12 Storey Mixed Use Apartment Building Concern letter about new proposed Development Plan File #OZS-2020-0014

Date: 29th November 2020

Figure 1 - community design guidelines and city file number P26SB.45-5.001 subdivision file number 21T-01100B (2008, p. 56)

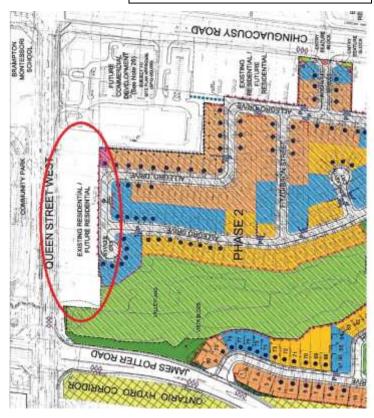
- a. Zoning Concerns:
 - The proposed building is being built in an area zoned for low-density development.
 - When the residential area was being developed in 2008 year, this location was designated for existing or future residential in which the property was zoned for "low density 2 residential character area 3", based on the City of Brampton Community Design Guidelines for Credit View Crossing (city file number P26SB.45-5.001 subdivision file number 21T-01100B (See Fig 1, p. 55-56).

Figure two - Resident Purchase Agreement

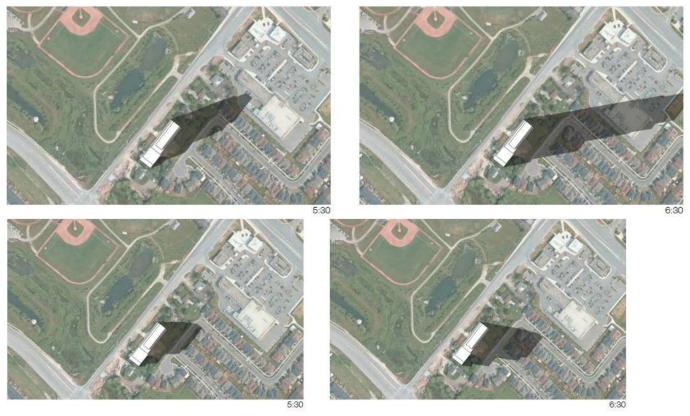
- When Some Residents Purchased in 2013-2014 (dates me vary for everyone) the proposed site was Still Listed as Existing or Future Residential (nothing about Future Commercial Development) See Fig 2

Note: Property Listed as Existing or Future Residential (nothing about Future Commercial Development)

Figure #4 - 12 Storey Building Shadow Cast April in peak summer will be greater

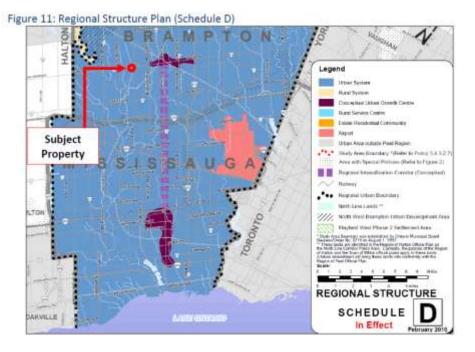
- a. Due to the height of the proposed 12-storey apartment, (46.45m or 152 feet) it will block the evening sunlight affecting the residents of Allegro Street, Byville Court, and surrounding streets.
- b. Due to blocking of sunlight, building will cast evening shadow from approximately 2PM sunset Affecting Approximately 30% of neighbourhood homes, Please look at Figures #4 Shadow Cast.
- c. Due to the height of the building, it will block the natural passage of air/wind circulation.
